MITSUI E&S Machinery	co., Ltd.		
for MITSUI—MAN B&W engines, Product Safety Warning for TCA type turbocharger		No.203	
		APPROVED	M.Kobayashi
		CHECKED	
		PREPARED	T.Matsubara
ENGINE TYPE	TCA type turbocharger (TCA55, TCA66, TCA77)	DATE	2021.02.17
ENGINE LYPE			neasures as ered from a ed from the this warning er while the conventional on Figure 1,2 the priority risk.

Product safety warning for TCA55, TCA66 & TCA77

Addendum Safety Instructions

Figure 2. Hazardous area (around turbocharger)

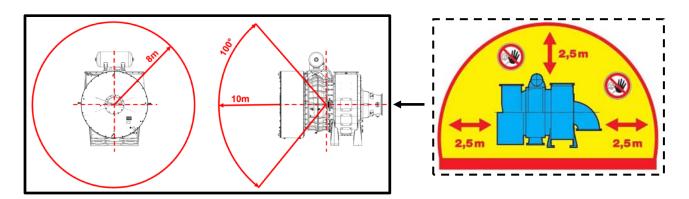
Detailed specifications of the affected turbocharger and information of the technical modification will be informed after confirmed with the licensor.

[Left:recommendation of this letter, Right:recommendation of conventional instruction manual]

Maintenance	Recommendation
Inspection for abnormal noise	In case of an abnormal noise, stay out of the hazardous area.
and vibration	Stop the engine immediately. Engine can be re-started after
	eliminating the cause of the problems.
Check pipes	Inspect when the engine is stopped.
Check the fixing screws	Inspect when the engine is stopped.
Turbine dry cleaning	Carry out when the engine load is reduced.
Turbine wet cleaning	Carry out when the engine load is reduced.
Compressor wet cleaning	Don't carry out. (See MITSUI Mini News No.80.)
Cleaning of air filter	Carry out when the engine is stopped.
	Use air-filter without breakage and holes.
	Don't check U-tube manometer when engine is running.
Inspection of sealing air valve	Inspect when the engine is stopped.

Fig. 1: Example of an optimized path around the engine

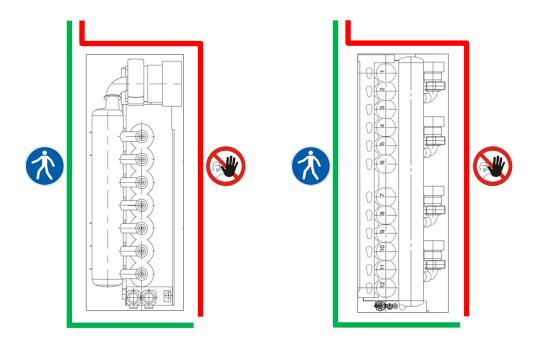
In any case please optimise your path through the engine room in order to minimize your stay in the hazardous area (Figure 1).

Work item	Description in the manual	Recommendation
901 / 501	Inspection for abnormal noise and vibrations	Stay out of the hazardous area (ref. Fig. 1) for this inspection. In case of an abnormal noise stay away from the turbocharger, stop the engine immediately, identify and eliminate the source of the noise before re-starting the engine.
903	Check turbocharger and system pipes for leaks	Carry out this work only when engine is stopped. Oil leaks as well as gas leaks can also be identified by residues when the engine is stopped.
905 / 508	Check all the fixing screws, casing screws and pipe connections for tight fit	Carry out this inspection only when the engine is stopped.
911 / 504	Turbine wet cleaning	Use it regularly at reduced engine load according to the description of turbine wet cleaning.
913 / 503	Turbine dry cleaning	Use it regularly according to the manual but not above 50% MCR.
915 / 502	Compressor wet cleaning	Use it regularly according to the manual, but not above 50% MCR.

Fig. 2: Red zone = extended safety zone (extended compared to the safety zone which is defined in the Instruction Manual)

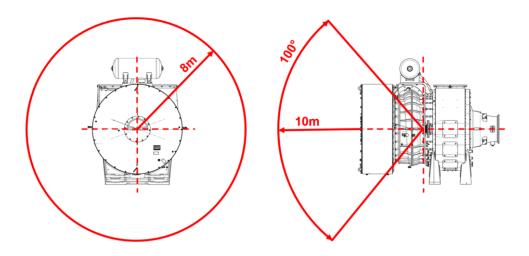
During extended maintenance work a longer stay in the engine room may be necessary. In this case please do not perform this work in the extended safety zone (Figure 2).
